Part 2 — Technical Requirements

Application under the *Agricultural Operation Practices Act* for a confined feeding operation, manure collection area, and/or manure storage facility(ies)

NRCB USE ONLY <input type="checkbox"/> Approval <input type="checkbox"/> Registration <input checked="" type="checkbox"/> Authorization <input type="checkbox"/> Amendment	Application number <div style="font-size: 1.2em; font-weight: bold;">LA25042</div>	Legal land description <div style="font-size: 1.2em; font-weight: bold;">NE 32-1-14 W4M</div>
---	---	--

River Road Farming
Corporate name (if applicable)

Surface water control systems

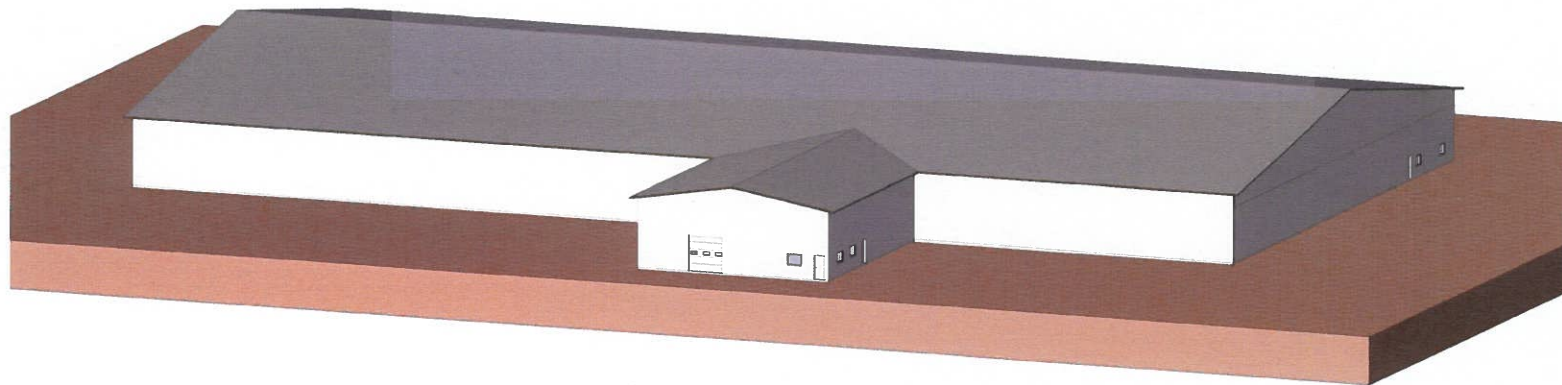
AO Comment: Area is within a barn, no run-on or run-off.
